STAFF REPORT

SUBJECT: H-2022-0069
Bridge at The Village at Meridian

I. PROJECT DESCRIPTION

Conditional Use Permit to exceed the maximum building height listed in UDC 11-2B-3A.3 of 65 feet for the C-G zoning district to allow an average elevation of 78 feet (85 feet to the highest point of the structures).

BUILDING
SECTIONS

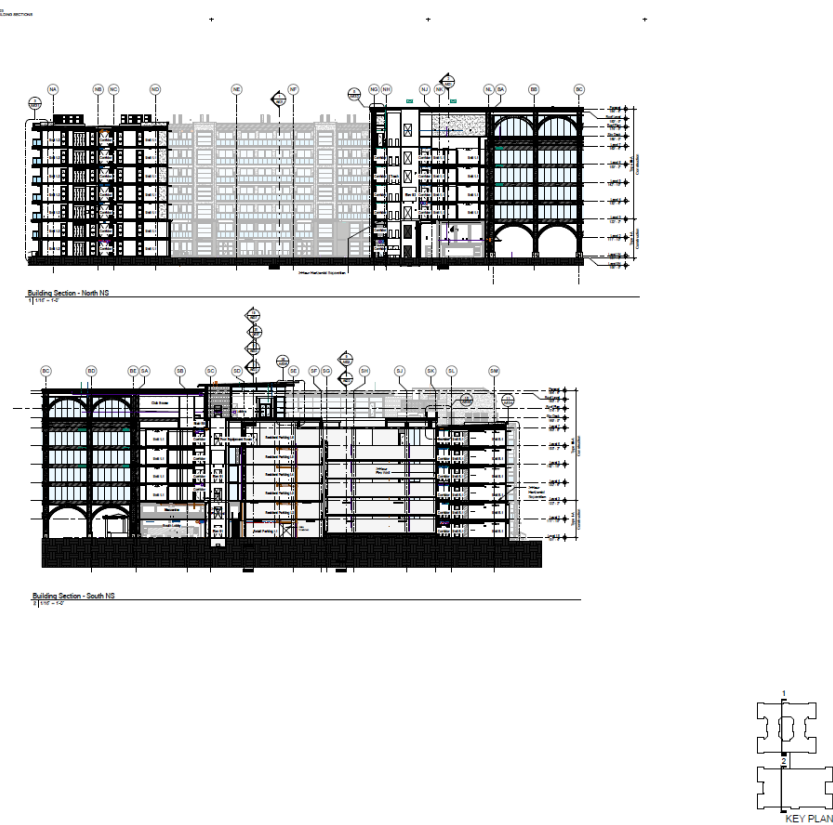
2. No occupancy uses shall be permitted above the 74'5" level (i.e. rooftop gardens, etc.) per requirement of the Fire Department.
3. The proposed structures shall not exceed an average elevation of 78 feet (85 feet measured to the highest point of the structures).
